27/12/19

E4

PLINTH BEAMS

27/12/19
E5
PLINTH BEAMS

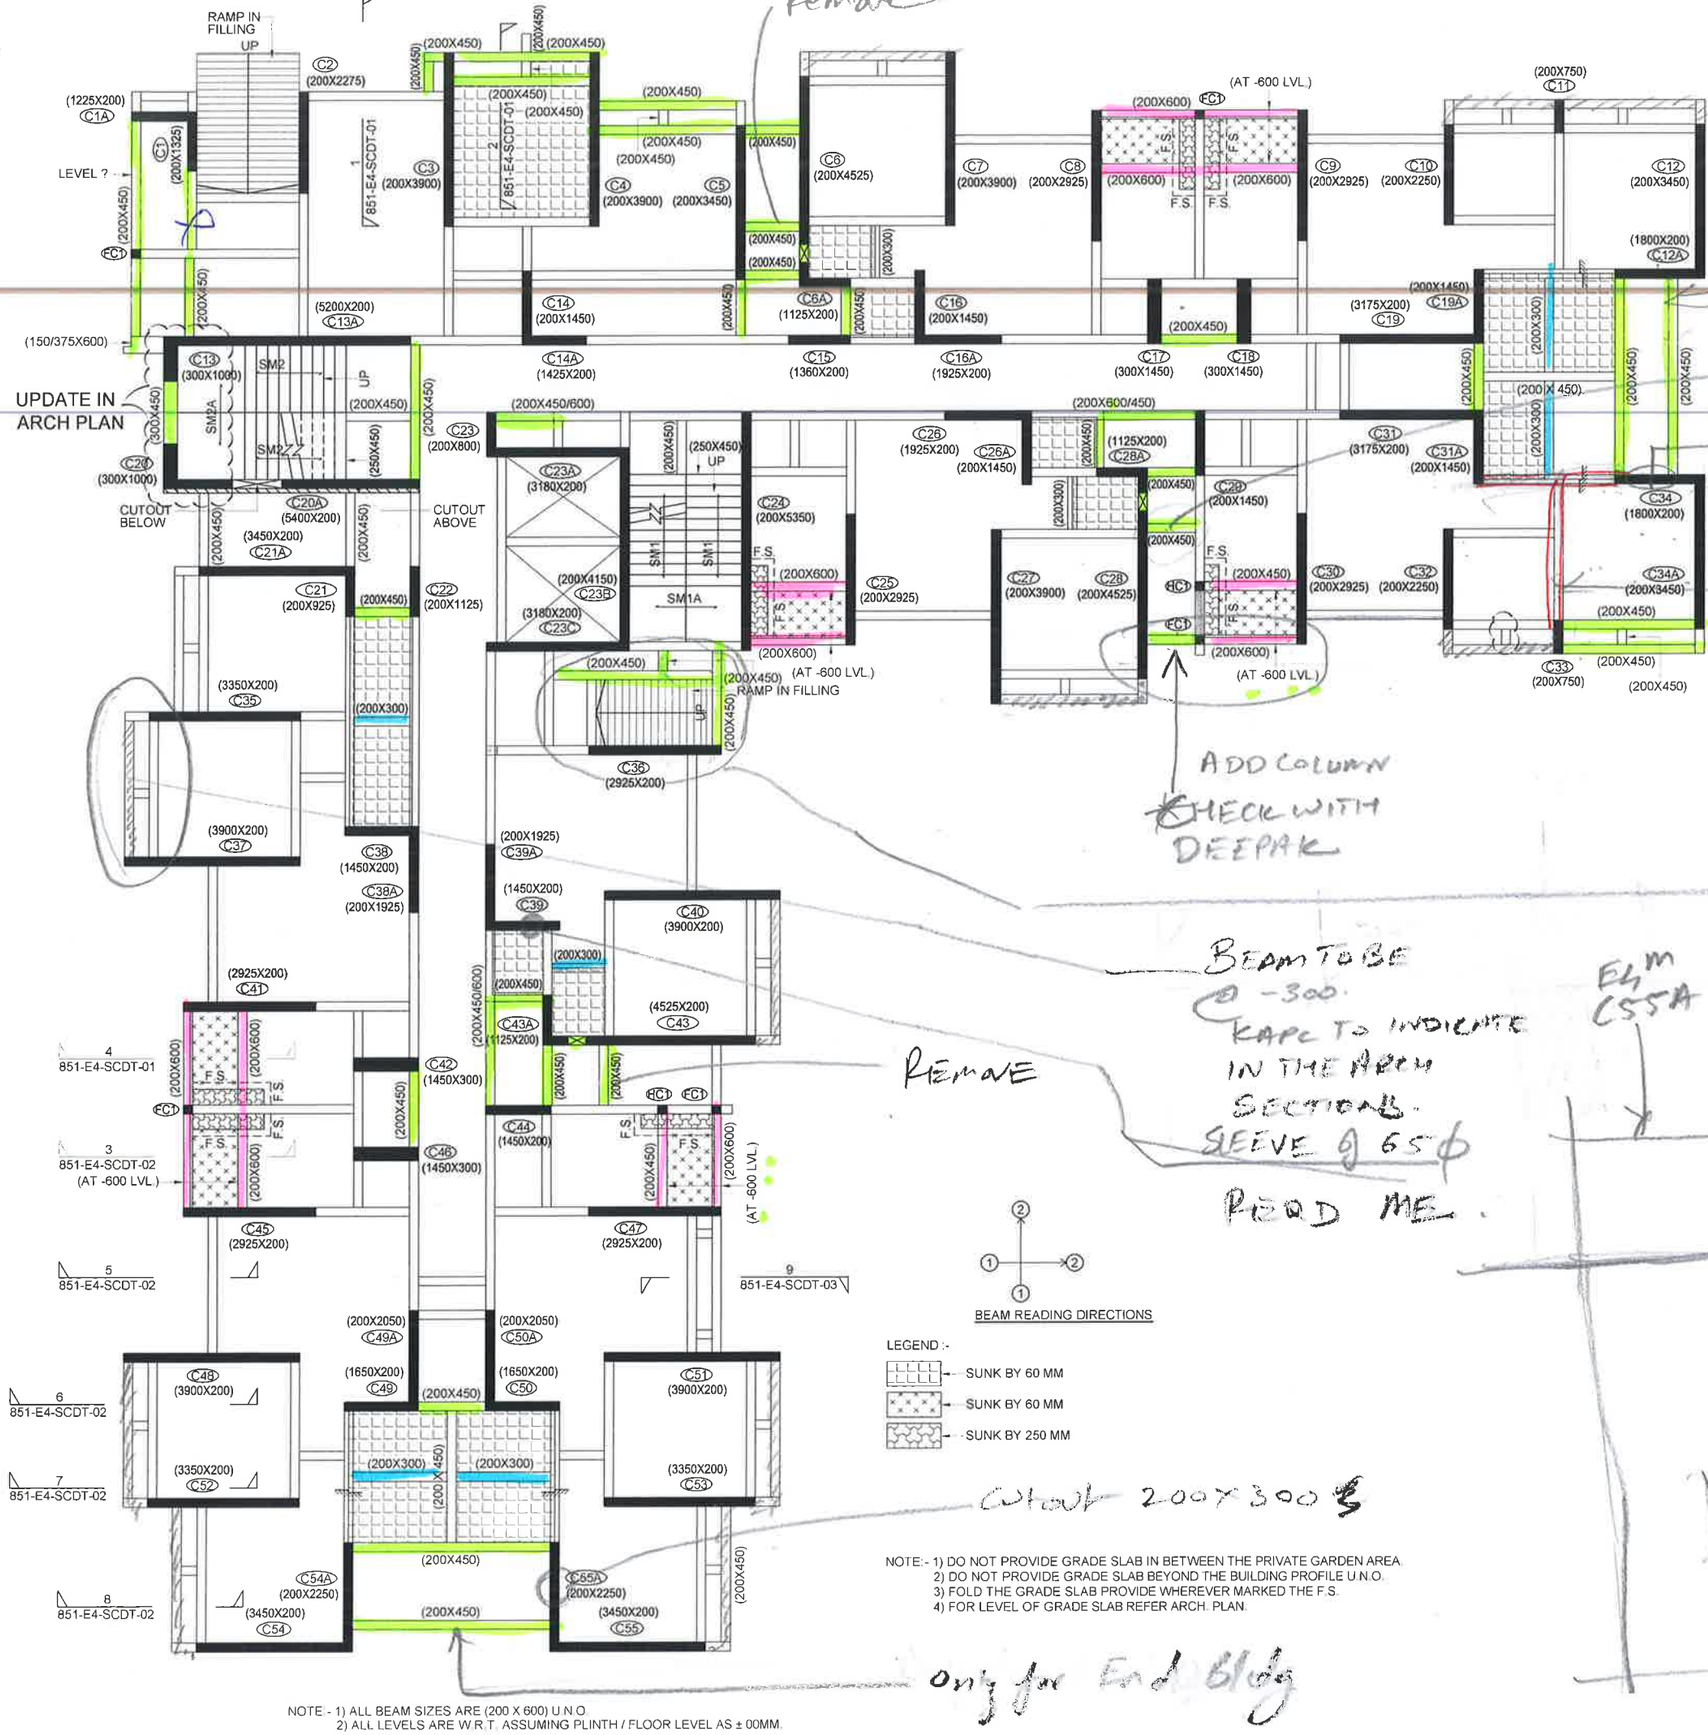
Remove

Only for End Bldg

Remove

Cutout of 200 x 300 in C34 & C55A 450 DEPTH SUBHASH TO CHECK...

TO BE DISCUSSED NEXT WEEK

RAMP IN FILLING UP

LEVEL ?

UPDATE IN ARCH PLAN

CUTOUT BELOW

CUTOUT ABOVE

(AT -600 LVL.)

RAMP IN FILLING

ADD COLUMN

CHECK WITH DEEPAK

BEAM TO BE @ -300. KAPC TO INDICATE IN THE ARCH SECTIONS. SLEEVE @ 65ϕ

REMOVE

Cutout 200 x 300 ϕ

Only for End Bldg

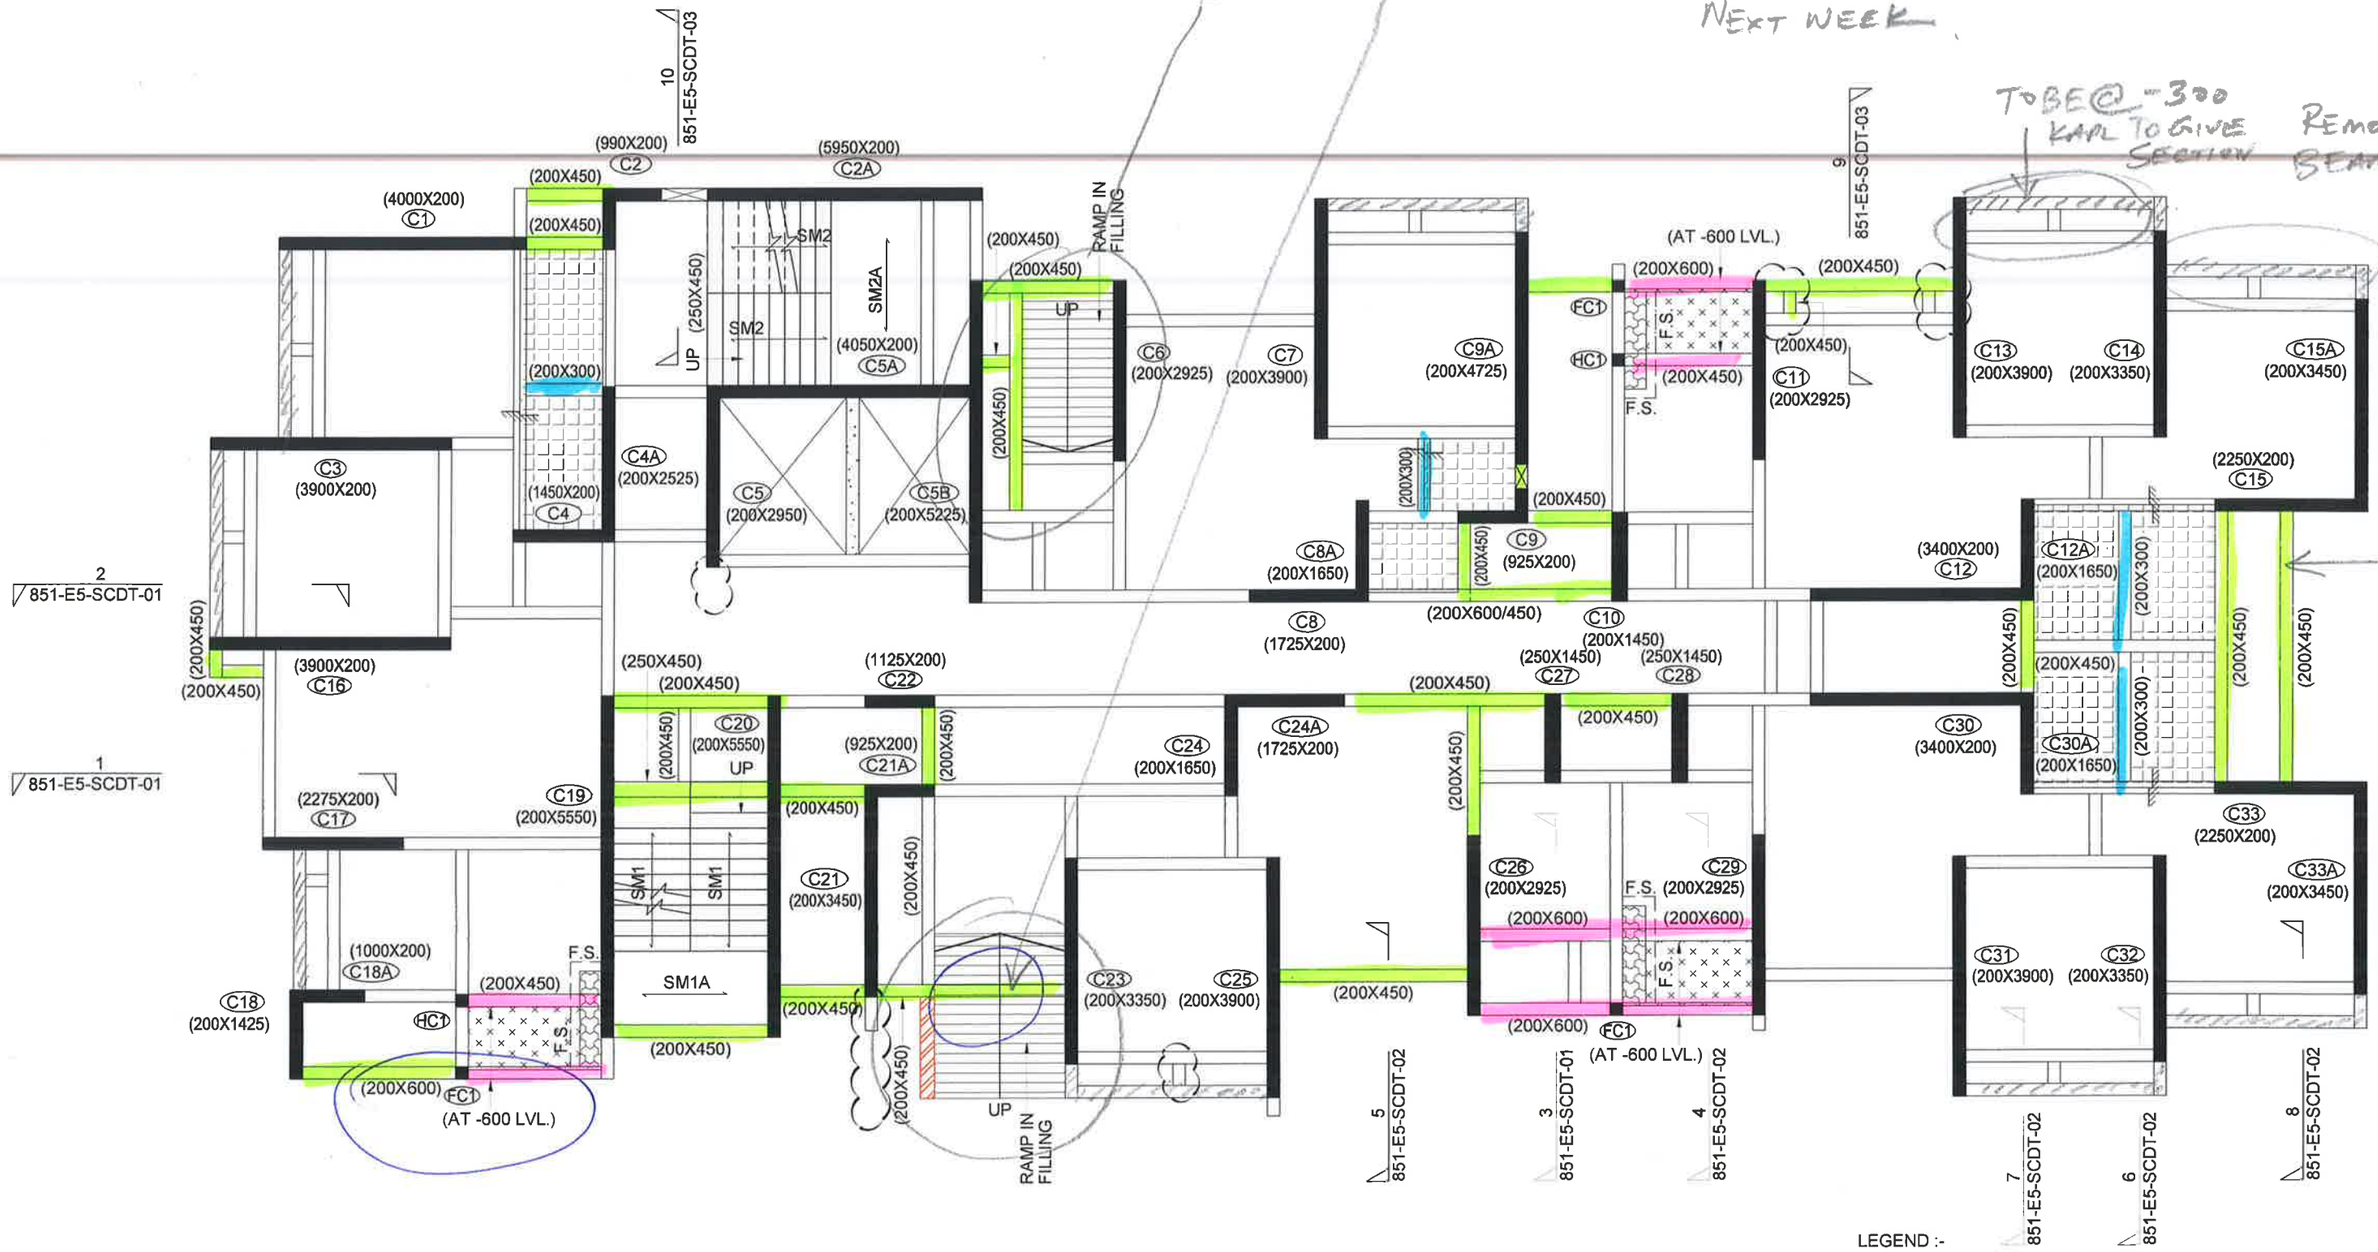
TO BE DISCUSSED NEXT WEEK

TO BE @ -300 KARL TO GIVE SECTION

REMOVE BEAM
